Interactive comment on “Structural geology and geophysics as a key to build a hydrogeologic model of granite rock to support a mine” by L.Martinez Landa et al.

C. Juhlin (Referee)

Received and published: 5 March 2016

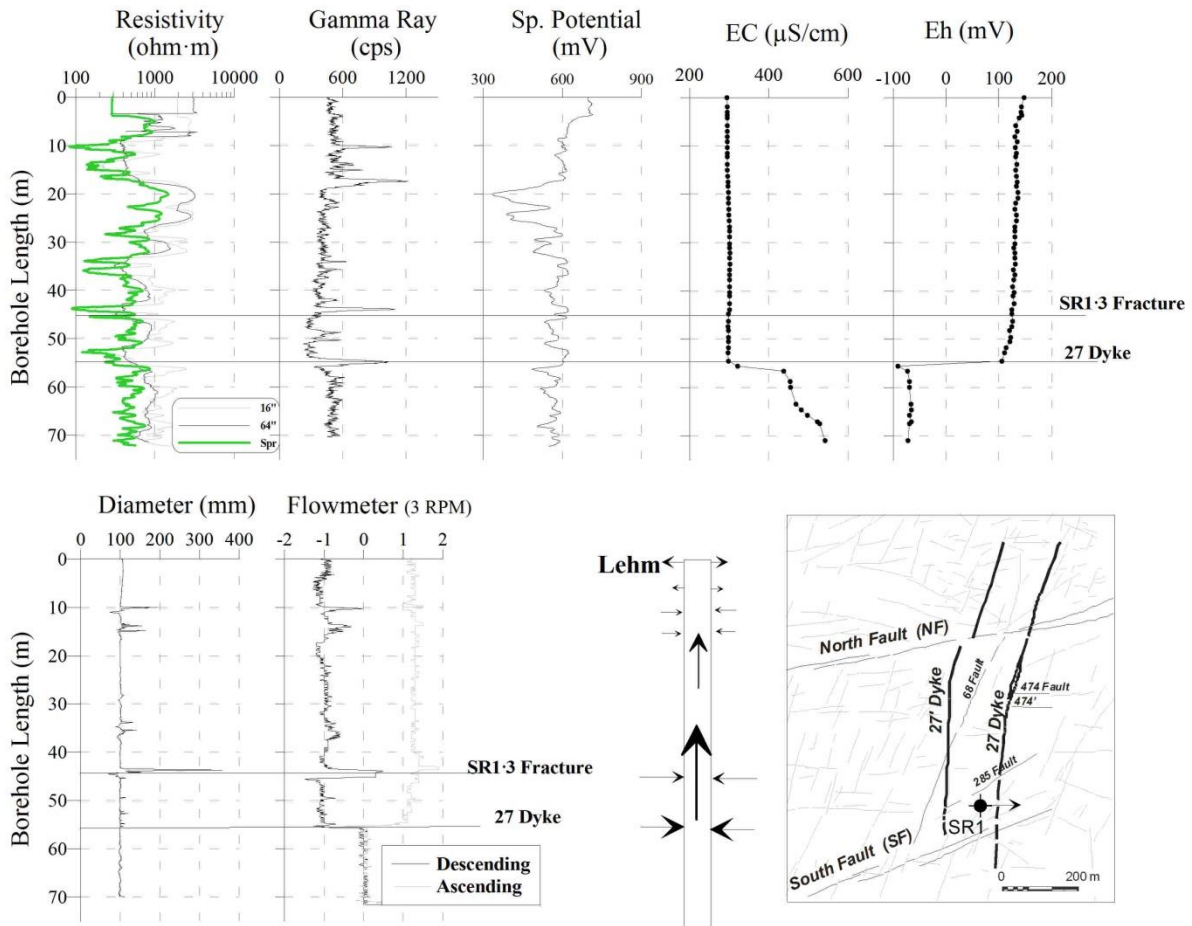
pg 5, line 15: There is no temperature log in Figure 4!

Figure 4: I do not see how the geophysical logs helped identify the dyke. There should be a large difference in the gamma log between the granite and the ~~diabase~~ quartz dyke. Please explain. Resistivity is normally plotted using a log scale (done). Also, the resistivity seems quite low for in-tact granite. Please elaborate on this.

Sorry, we had changed the figure giving up some profiles as temperature, pH and dissolved oxygen, but not the text, which now reads:

We have also modified the caption of Fig.4, which now reads:

Some of the chemical and geophysical logs recorded at borehole SR1, which helped to identify dyke 27 and fracture SR1-3. The chemical logs only display the effect of dyke 27, because all upper water (including SR1-3) is mine water. The effect of both structures can be noticed in the other logs, especially in the gamma log, due to fracture filling. Flow meter values, recorded with an upward flow-rate of pumping indicate little water flow beneath dyke 27. The same applies to a lesser extent to fracture SR1-3.

These logs are performed at the SR1 borehole, which is located on the not mined part of the 27 quartz dyke, but very close of the mined portion. The granite body is strongly weathered and with a high fracturation index at the first 200m depth. It is for this reason that we have made units differentiation inside the granitic body, depending on the state of the granite the hydraulic behavior are different. This explanation could be explaining the measured values.

We change the scale of resistivity to log scale. The figure 4 has been modified as follow:
